| <b>Project Title:</b>   | MARIPOSA ENERGY PROJECT - Compliance       |
| <b>Document Title:</b>  | Staff Response to Robert Sarvey's Comments |

**SUBJECT: MARIPOSA ENERGY PROJECT (09-AFC-3C)  
Staff Response to Robert Sarvey's Comments**

Photo shows installed shielded light fixtures on the exhaust stacks and perimeter lighting fixtures (Holophane Mongoose lighting luminaires) for the Mariposa Energy Project. (Dec. 6, 2012)

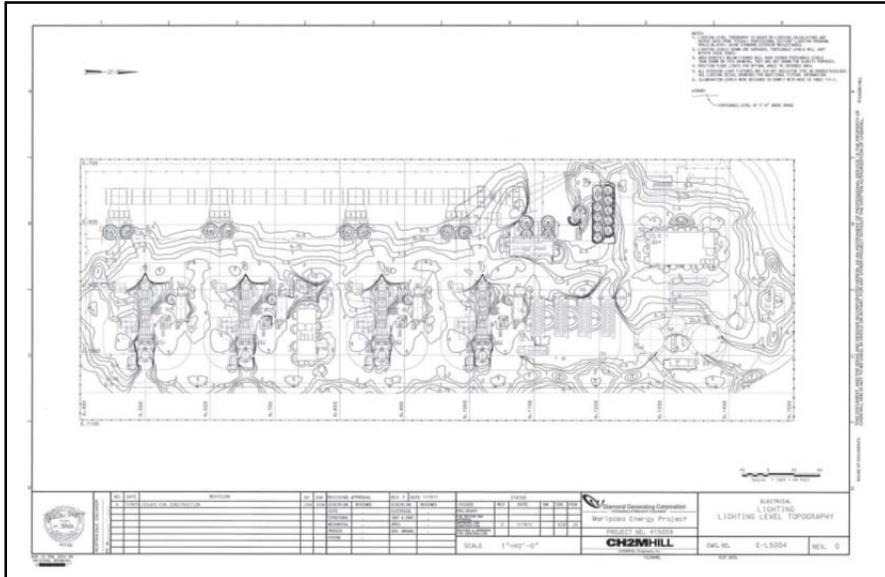
The installation of permanent exterior lighting for the facility was completed in May 2012. All exterior light fixtures are cut-off reflector type or hooded/shielded. Flood lights are positioned for optimal angle to intended area. See photos below. Staff found no written record of a light trespass complaint being received as of July 1, 2015.
